Access Compliance Report

Public Rights-of-Way

(Curb Ramps)

Intersection ID: 53162	Main Street: OBAN_CT	Cross Street: HAMILTON_BRIDGE_RD	Location: SW
ADA ID: E1E07ADADD9	Ramp Type: BlendTrans1	Initial Pass/Fail: Fail	Overall Compliance: No
Severity Score: 8.75			
Codes/Mitigation Info/Possible Solution		Field Measurements/Component Compliance

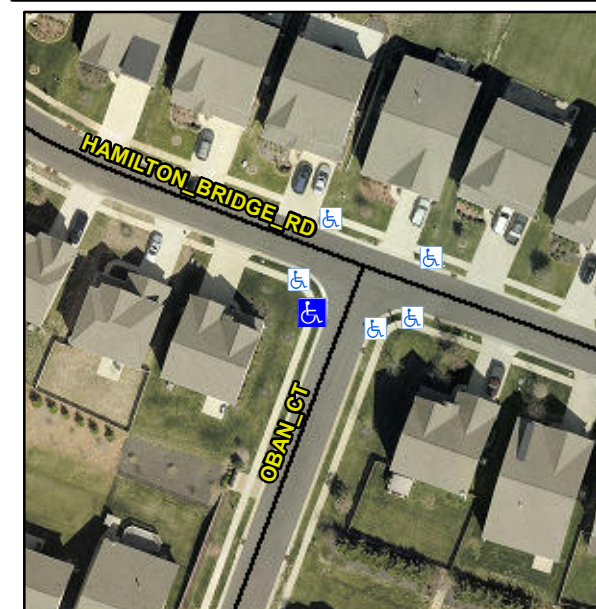
Compliance	Description	Data	Compliance	Description	Data
N/A	Ramp Length (in)	48.0	Yes	BlendTrans Slope (%)	2.1
No	Ramp Width (in)	45.5	Yes	BlendTrans XSlope (%)	0.4
N/A	Flare Type LT	N/A	N/A	Flare Type RT	N/A
N/A	Flare Slope LT (%)	N/A	N/A	Flare Slope RT (%)	N/A
N/A	Flare Traversable LT?	N/A	N/A	Flare Traversable RT?	N/A
N/A	Landing Length (in)	N/A	N/A	DWS Provided?	N/A
N/A	Landing Width (in)	N/A	N/A	DWS Contrast?	N/A
N/A	Landing Slope (%)	N/A	N/A	DWS Length (in)	N/A
N/A	Landing X Slope (%)	N/A	N/A	DWS Full Width?	N/A
N/A	Landing Curb? (Y/N)	N/A	N/A	DWS Offset (in)	N/A
N/A	Shared Landing?	N/A			
N/A	Gutter Ponding?	N/A	N/A	Gutter Slope (%)	N/A
N/A	Gutter Lip Ht (in)	1.3	N/A	Gutter X Slope (%)	N/A
N/A	Painted X Walk1?	No	N/A	Painted X Walk2?	N/A
	X Walk 1 Direction	To SE		X Walk 2 Direction	N/A
	X Walk 1 Width (in)	N/A		X Walk 2 Width (in)	N/A
	X Walk 1 Slope (%)	2.6		X Walk 2 Slope (%)	N/A
	X Walk 1 X Slope (%)	2.9		X Walk 2 X Slope (%)	N/A

N/A	Ramp inside XWalk1?	N/A	N/A	Ramp inside XWalk2?	N/A
	Road Slope (%)	2.9		Clear Space?	N/A
	Road X Slope (%)	2.6	N/A	Clear Space to XWalk (in)	N/A
N/A	Any Obstructions?	N/A	N/A	Storm Grate/Utility Hazard?	N/A
	Obstruction Type			Storm Grate/Utility Type	
		N/A			N/A
			Yes	Surface Condition? (G/P)	Good
			N/A	Curb Slope (%)	0.8

Remove & Replace Curb Ramp With Two New Directional Ramps or Equivalent.

R304.5.1
